STATE OF NORTH CAROLINA
DEPARTMENT OF TRANSPORTATION

July 13, 2018

Subject: Modification Request for USACE Individual Permit, Section 401 Water Quality Certification, Neuse Riparian Buffer Authorization and CAMA Major Development Permit for the proposed improvement of US 17 from south of Belgrade at SR 1330/SR 1439 to the New Bern Bypass, in Onslow, Jones and Craven Counties. TIP No. R-2514 B, C & D, COE Action ID: SAW-2008-00528. WBS 34442.1.3.

BUFFER DRAWING
SHEET 3 OF 20

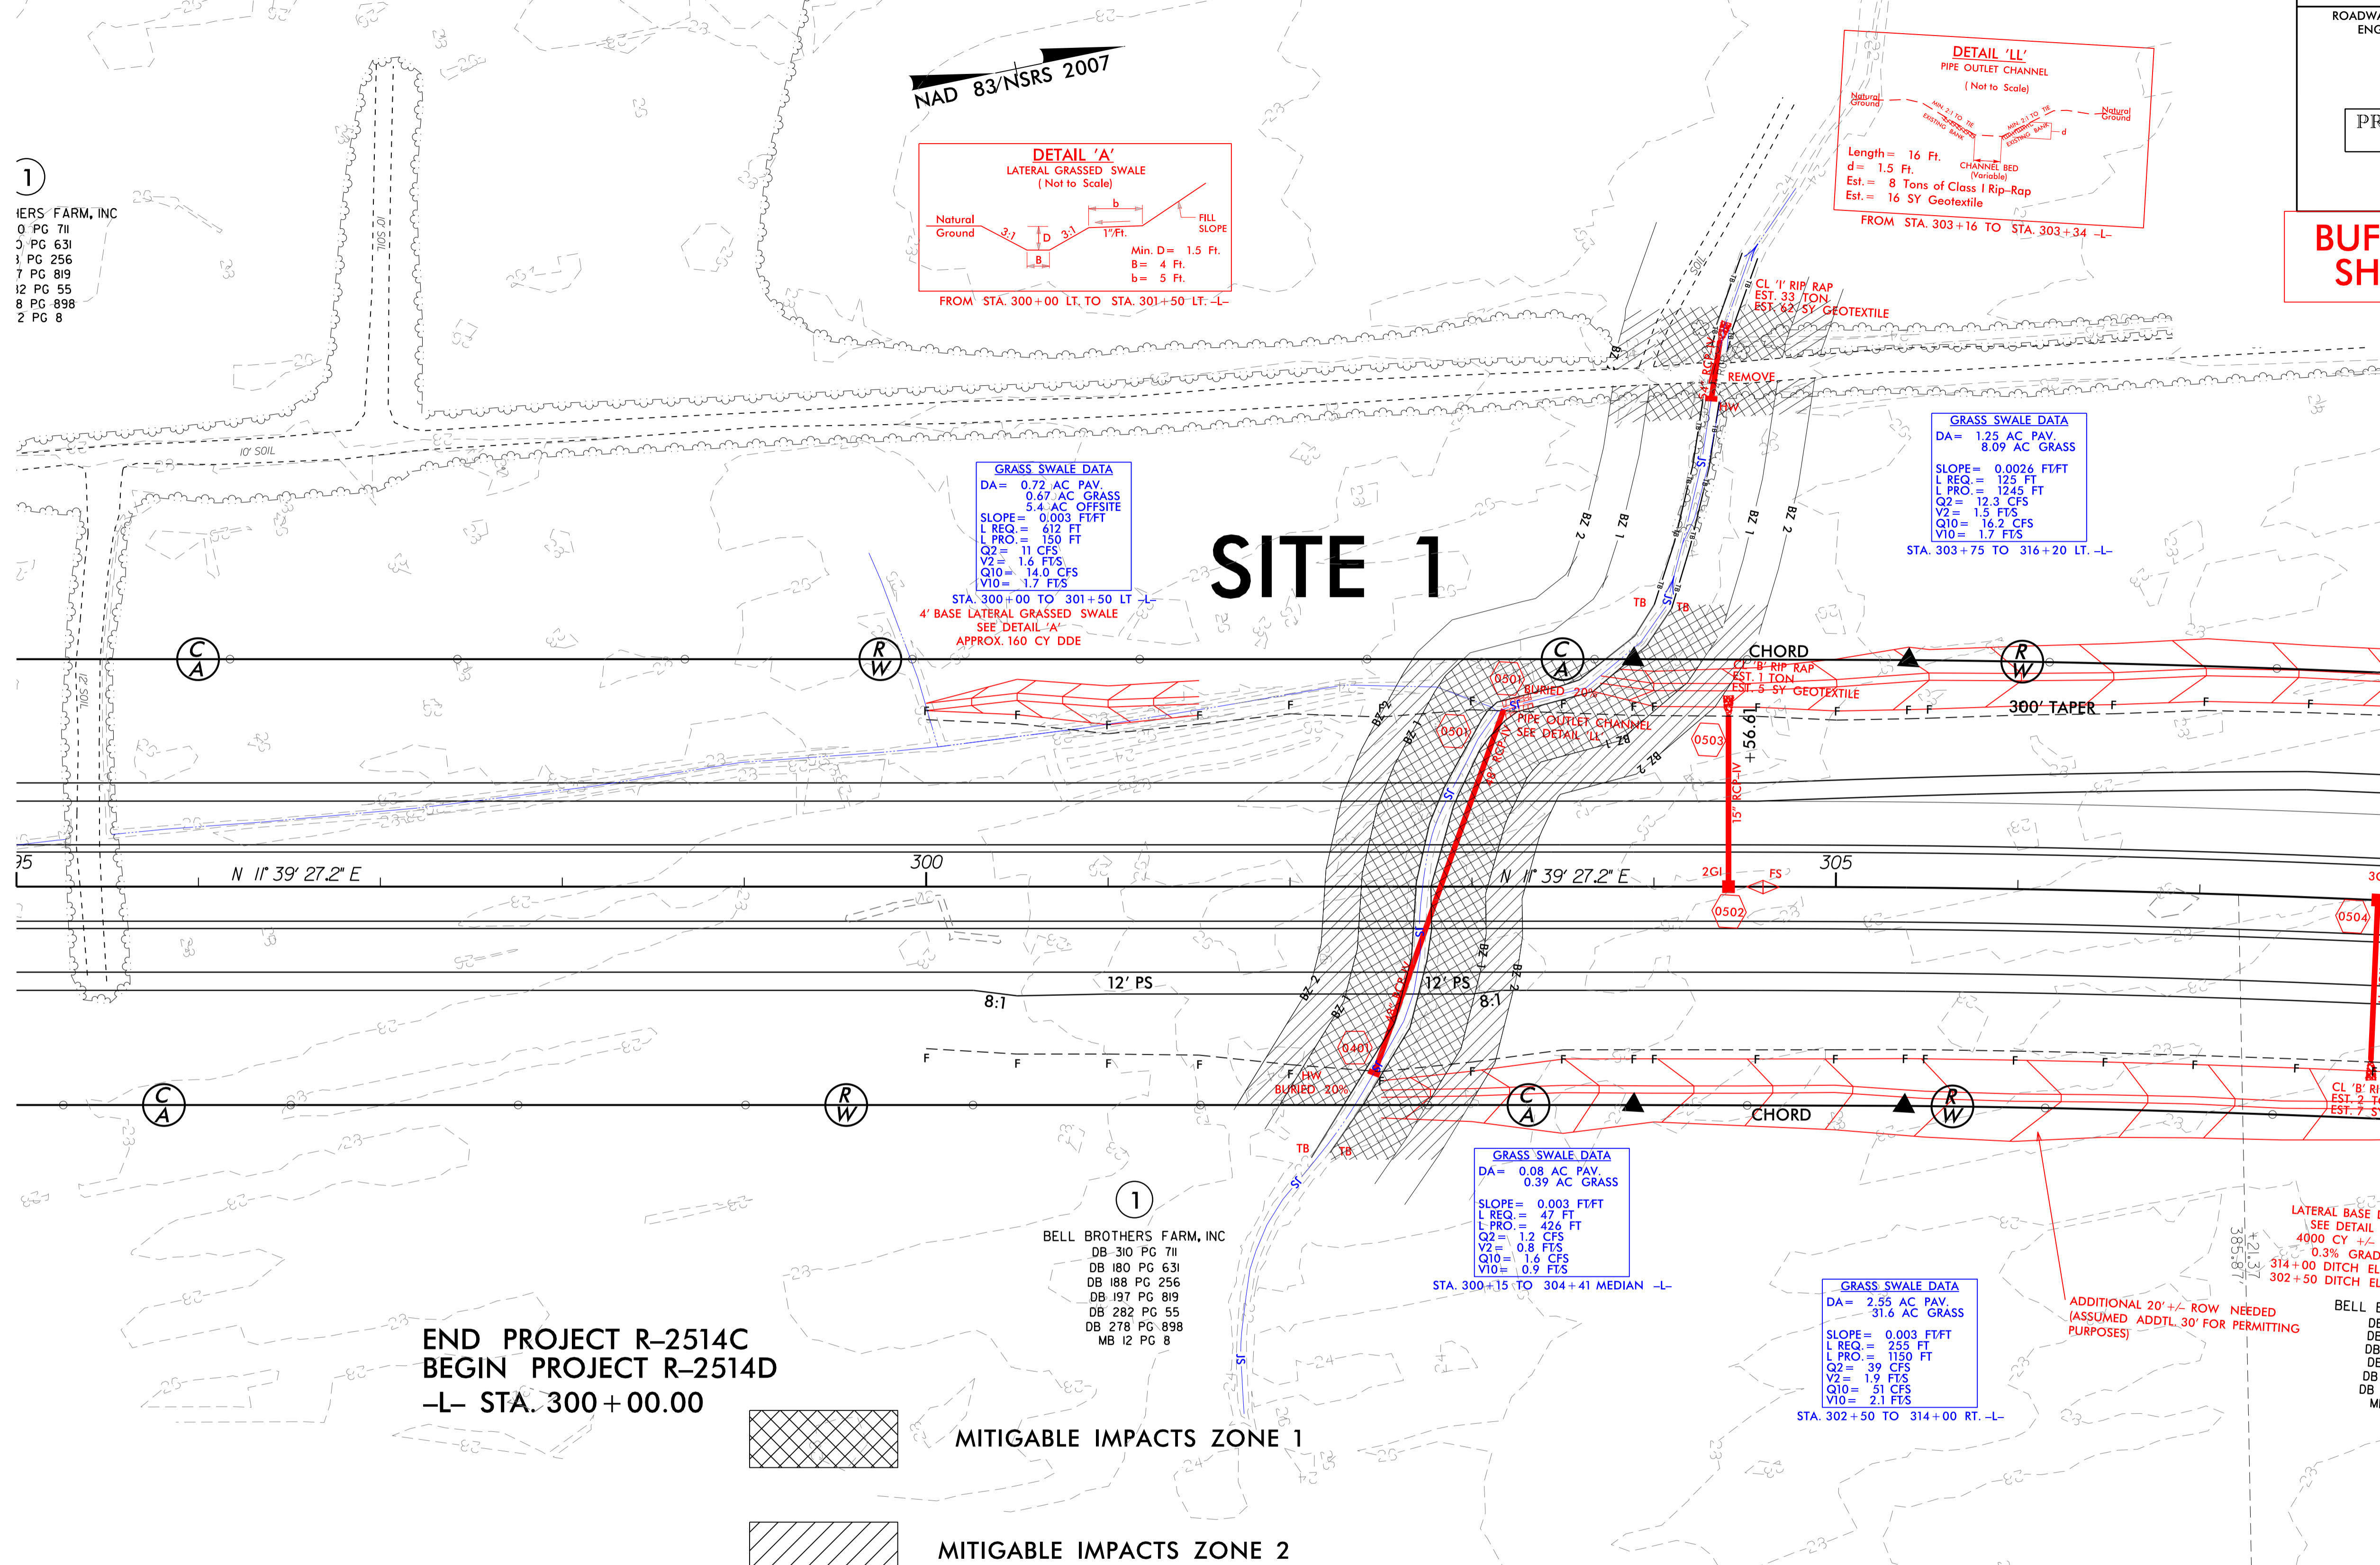
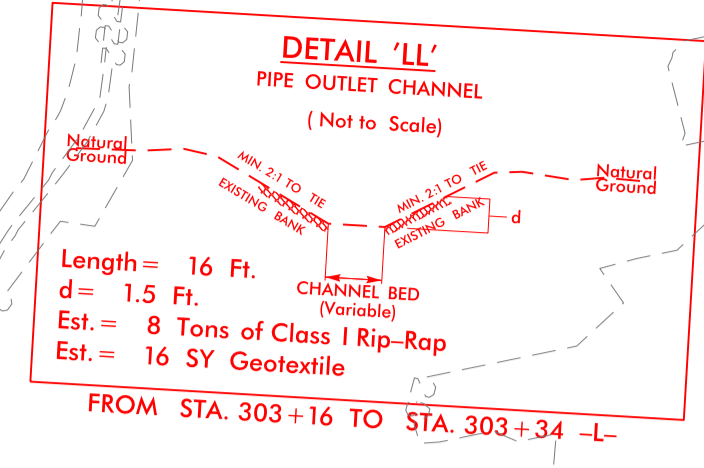
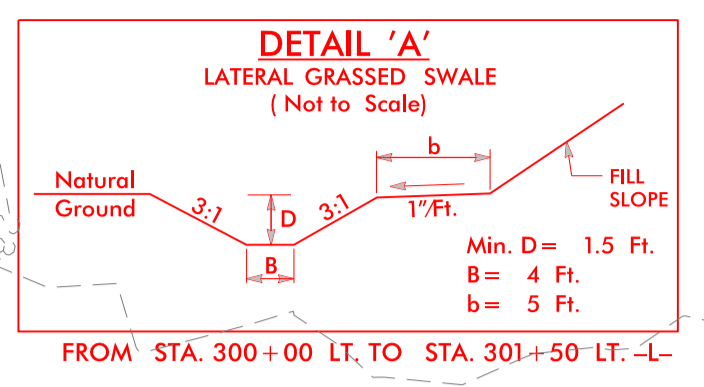
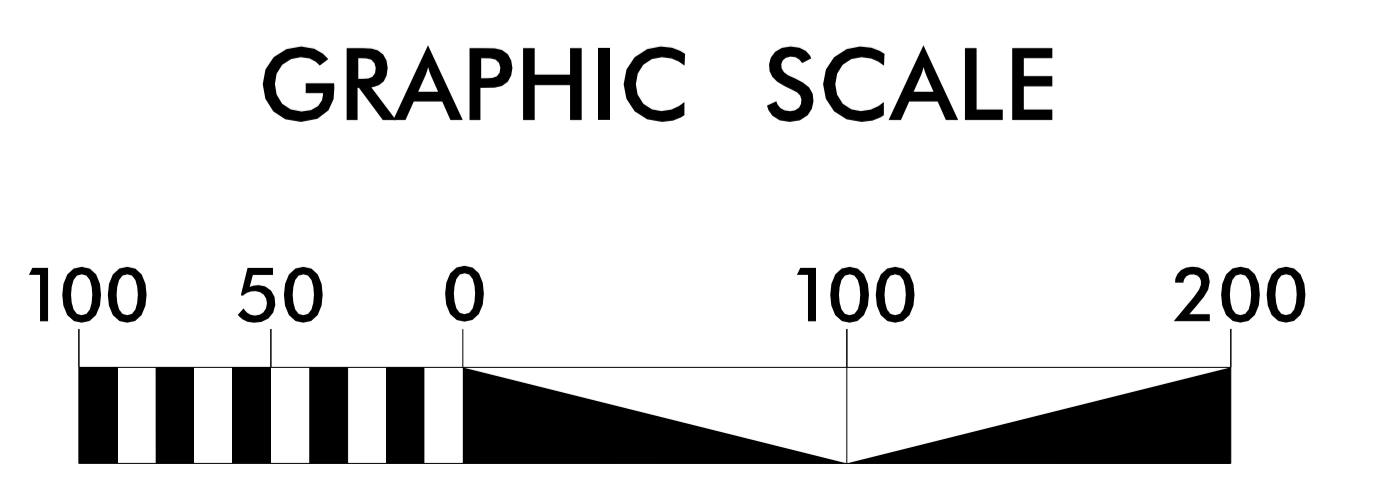
These modifications will require additional impacts to the stream and riparian buffers at this site, but no additional impacts to wetlands. Excavation through the riparian buffers is necessary in order to achieve an elevation low enough to drain the ponding that is occurring on the private properties. Permanent channel impacts increase by 127 feet. Streambank stabilization increases by 16 feet. Temporary channel impacts increases by 9 feet. Permanent surface water impacts increase by 0.01 acre. There are an additional 5,306 sq. ft. of buffer impacts in Zone 1, and 3479 sq. ft. in Zone 2, for a total increase of 8,785 sq. ft. Revised permit drawings are attached depicting these changes.

PONDING LOCATION

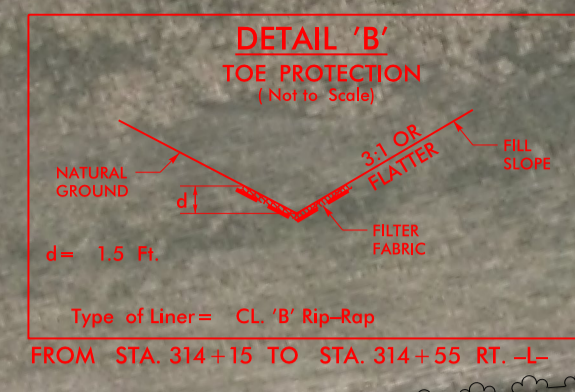
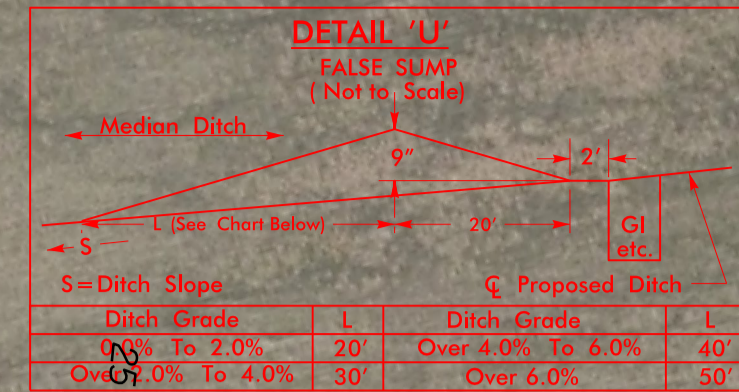
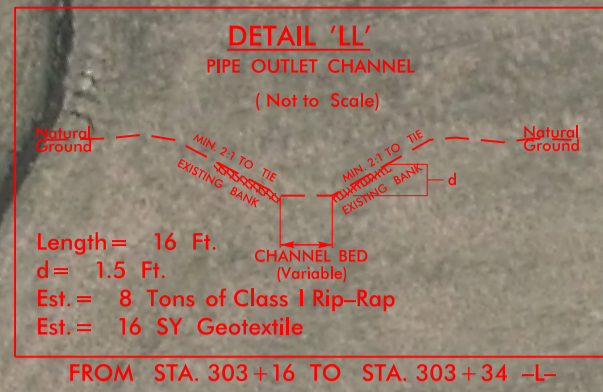
As you are aware, the North Carolina Department of Transportation (NCDOT) is constructing the US 17 project in Onslow, Jones and Craven Counties. Since roadway fill was placed, drainage problems have occurred at a specific location on the northern section of the project (R-2514D). NCDOT has received complaints from adjacent landowners about ponding at this location, which is immediately south of US 58. This problem area is located in uplands, and is not therefore depicted in the permit drawings. The attachments include a map showing the area of ponding.
